Georgia Power Company  
333 Piedmont Avenue  
Atlanta, Georgia 30308  
Telephone 404 526-6526

NED-85-444  
1766N

NRC DOCKETS 50-321, 50-366  
OPERATING LICENSES DPR-57, NPF-5  
EDWIN I. HATCH NUCLEAR PLANT UNITS 1, 2  
SUPPLEMENTAL INFORMATION ON SEISMIC DESIGN ISSUES

Pursuant to our commitment in the response to NRC question "Q4" attached to letter NED-85-391, dated May 13, 1985, a draft of FSAR revisions concerning seismic design and analysis is enclosed for your information. These revisions are expected to be sent to you in final form, along with other revisions being made in the next FSAR update, by July 22, 1985.

FIGURE 3.7A-22

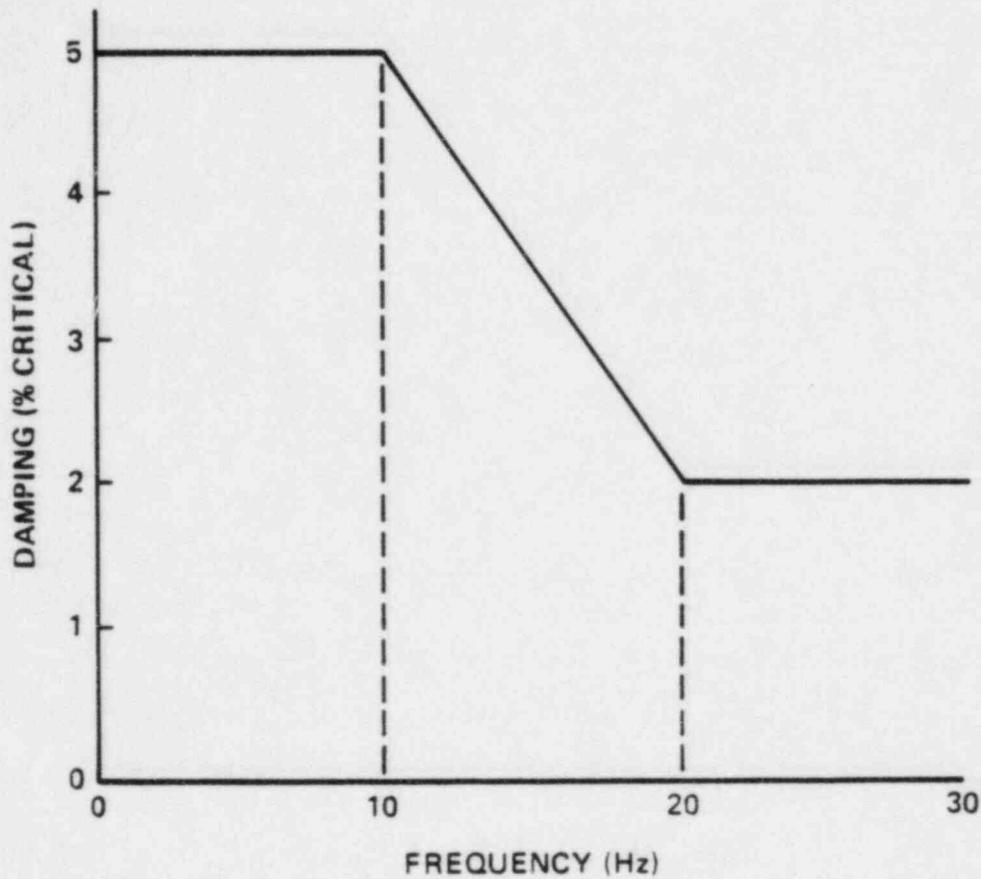
The seismic inputs to the original OBE and DBE piping systems analyses were defined using the 0.5-percent and 1.0-percent damped FRS, respectively. As of April 4, 1985, damping per figure 3.7A-22 is used in response spectrum analyses performed for all new and replacement systems and load reconciliation work. If as a result of using these damping valves, piping supports are removed, modified, or eliminated, the expected

1. Applicable to both OBE and DBE, independent of pipe diameter.
2. As of April 4, 1985, damping per this figure is used for all new and replacement systems and load reconciliation work.

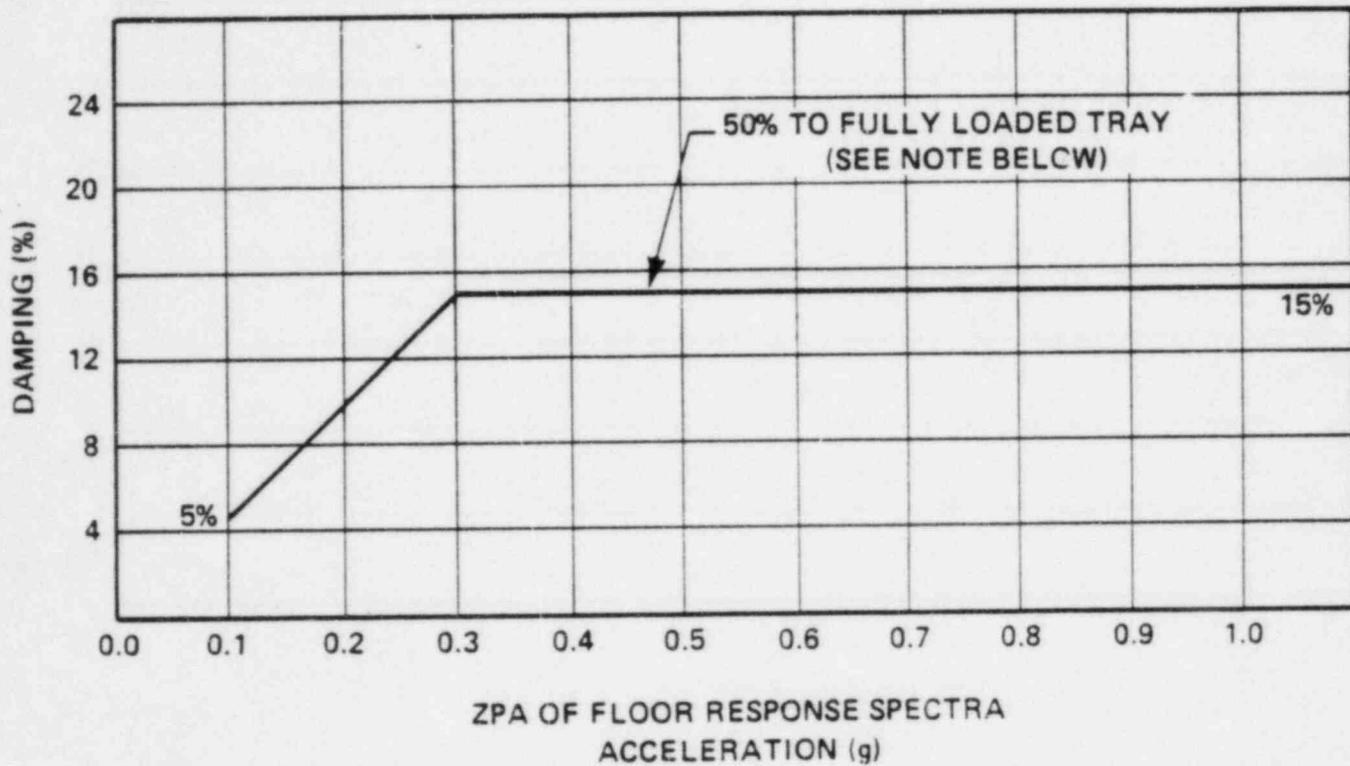
In the original cable tray support analyses, the applicable damping values were established, based upon the supports type of construction, using the values specified in table 3.7A-1. As of April 4, 1985, damping per figure 3.7A-23 is used for all new and replacement systems and load reconciliation work. The damping criteria specified in figure 3.7A-23 provide a conservative estimate of damping for cable tray supports based upon a test program. (6)

1. For unloaded tray, use damping values specified in Table 3.7A-1 for steel structures. For tray loaded less than 50% linear, interpolation is used to determine the applicable design damping value.
2. As of April 4, 1985, damping per this figure is used for all new and replacement systems and load reconciliation work.

FIGURE 12.3-2

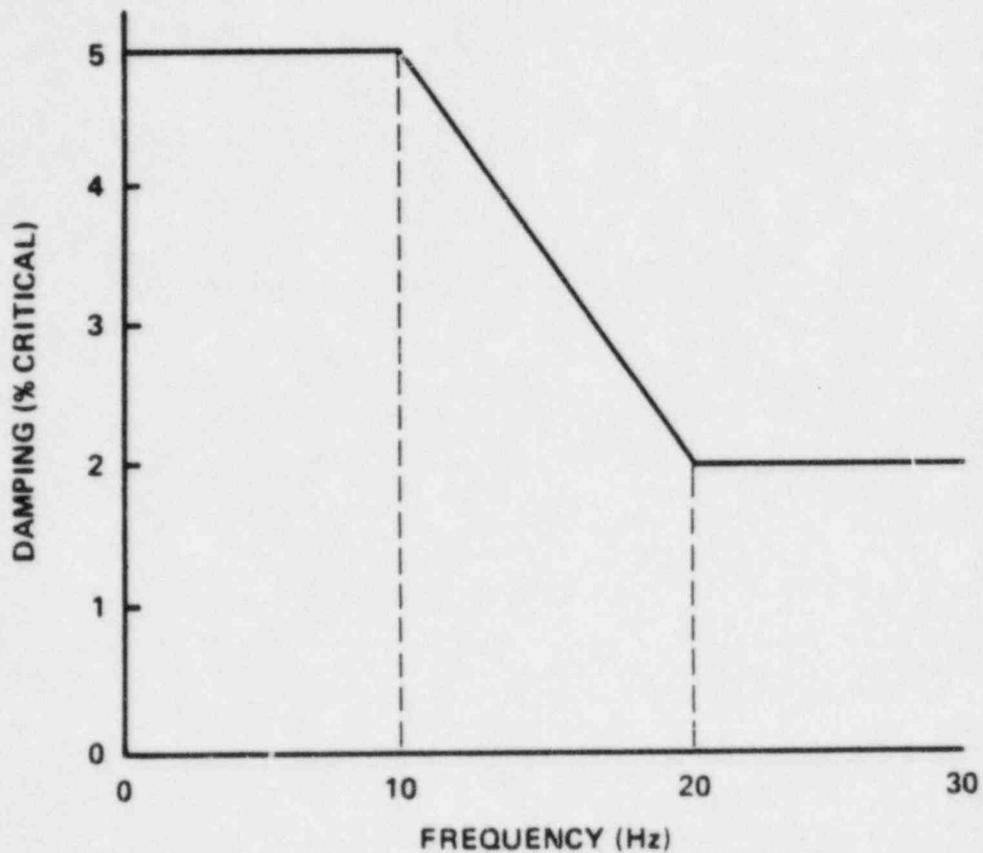
The seismic inputs to the original OBE and DBE piping system analyses were defined using the 0.5-percent and 1.0-percent damped floor response spectra, respectively. As of April 4, 1985, damping per figure 12.3-2 is used in response spectrum analyses performed for all new and replacement systems and load reconciliation work. If, as a result of using these damping values, piping supports are moved, modified, or eliminated, the expected increased piping displacements due to greater piping flexibility will be checked to assure that they can be accommodated and that there will be no adverse interaction with adjacent structures, components, and equipment. The damping criteria established by this figure are consistent with the frequency-dependent approach established by the Pressure Vessel Research Council Technical Committee on Piping Systems.<sup>(4)</sup>

- NOTES: 1. Applicable to both OBE and DBE, independent of pipe diameter.
2. As of April 4, 1985, damping per this figure is used for all new and replacement systems and load reconciliation work.

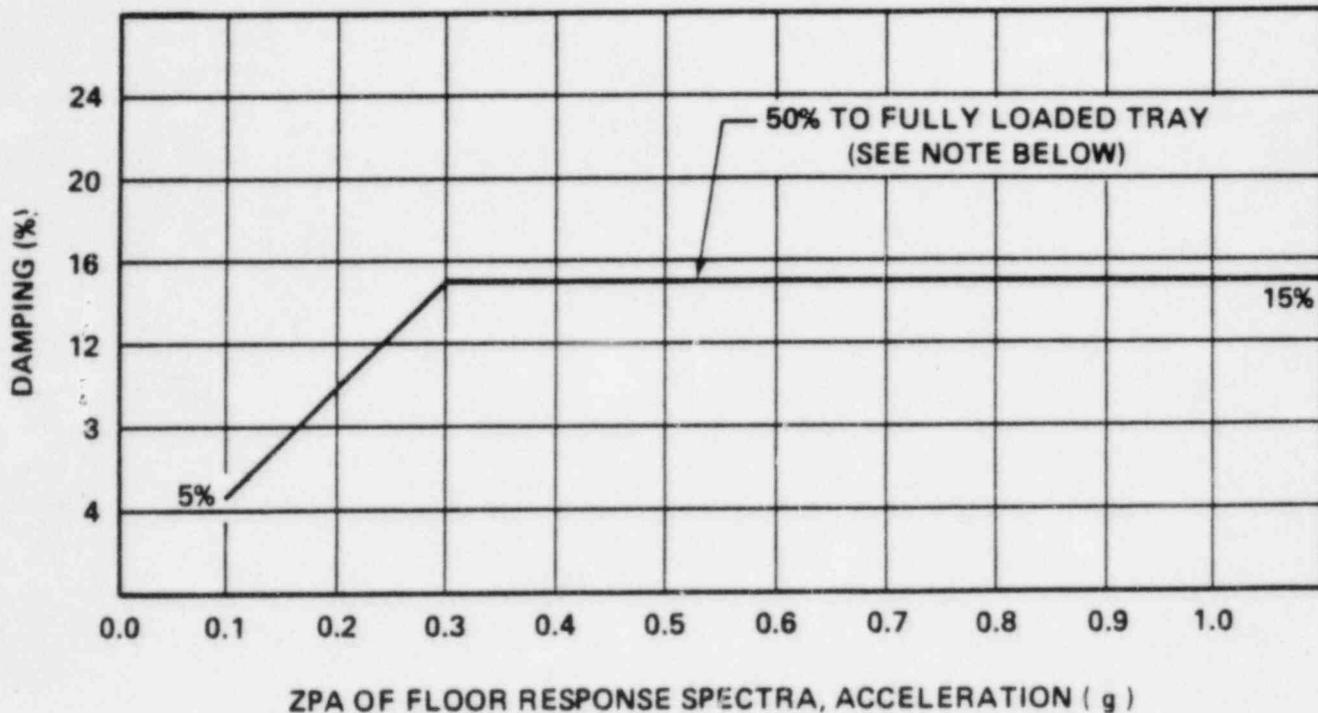
In the original cable tray support analyses, the applicable damping values were established, based upon the supports' type of construction, using the values specified in table 12.3-2. As of April 4, 1985, damping per figure 12.3-3 is used for all new and replacement systems and load reconciliation work. The damping criteria specified in figure 12.3-3 provide a conservative estimate of damping for cable tray supports based on a test program. (5)

- NOTES: 1. For unloaded tray, use damping values specified in Table 12.3-2 for steel structures. For tray loaded less than 50%, linear interpolation is used to determine the applicable design damping value.
2. As of April 4, 1985, damping per this figure is used for all new and replacement systems and load reconciliation work.
